802.3ck D1.4

162 cable assembly

162 A-D Annexes (TBDs)

Chris DiMinico
MC Communications/PHY-SI LLC/Panduit
cdiminico@ieee.org

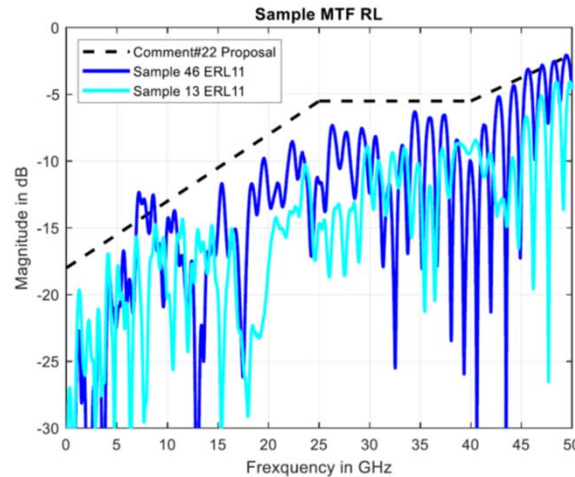
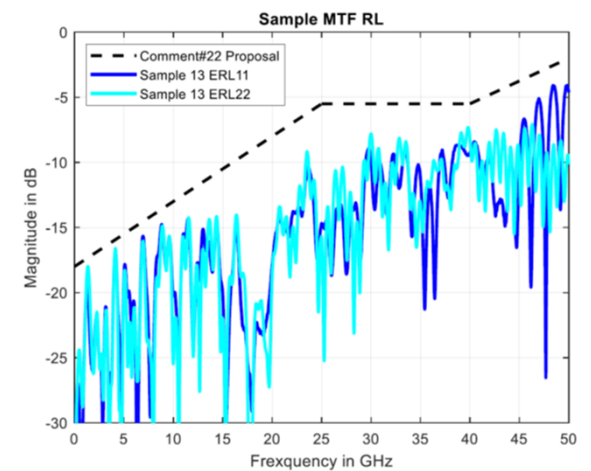
MTF ERL

- Specify MTF ERL with 9 dB requirement
- Use MTF ERL Parameters Table Below

Shown difference between ERL ~7dB and ERL ~8dB

Shown difference between ERL ~8dB and ERL ~10dB

The difference caused by the limit line violation >45GHz is ~0.2dB ERL

MTF RL

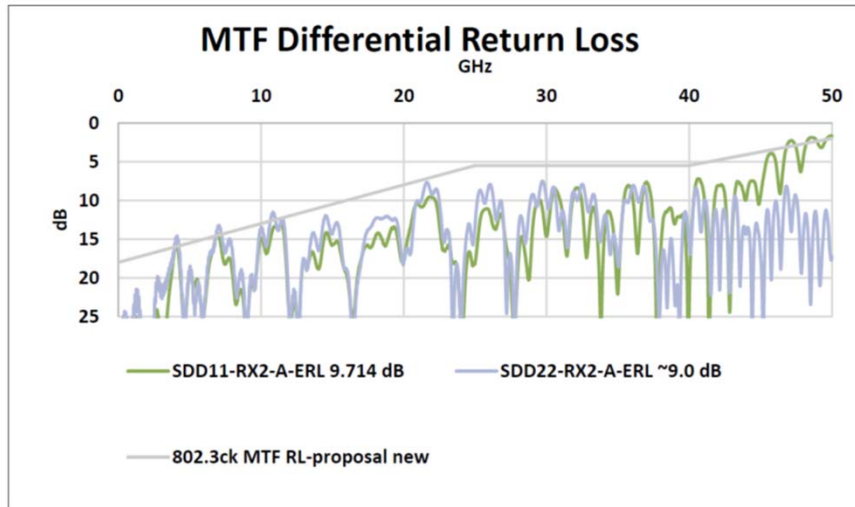
- MTF RL limit informative
- Change RL limit > 40 GHz

PROPOSAL: Differential Return Loss =

$$18 - 0.5 \cdot f_{\text{GHz}} \quad 0.05 \text{ GHz} \leq f_{\text{GHz}} < 25 \text{ GHz}$$

$$5.5 \quad 25 \text{ GHz} \leq f_{\text{GHz}} < 40 \text{ GHz}$$

$$-.35 \cdot (f_{\text{GHz}} - 40) + 5.5 \quad 40 \text{ GHz} \leq f_{\text{GHz}} \leq 50 \text{ GHz}$$

CI 162B SC 162B.1.3.2 P 256 L 46 # 22
 DiMinico, Christopher MC Communications
 Comment Type TR Comment Status R MTF RL

Modify Equation (162B-6) DRL(f) > 40 GHz to align with achievable MTF return loss

REJECT.

The following presentation was reviewed by the task force:
https://www.ieee802.org/3/ck/public/20_10/diminico_3ck_03a_1020.pdf

The response to closed comment #178 changes the differential return loss specification from normative to informative.

The RL mask proposed on slide 12 of diminico_03a relaxes RL at frequencies greater than 40 GHz.

There is no consensus to make the proposed change.
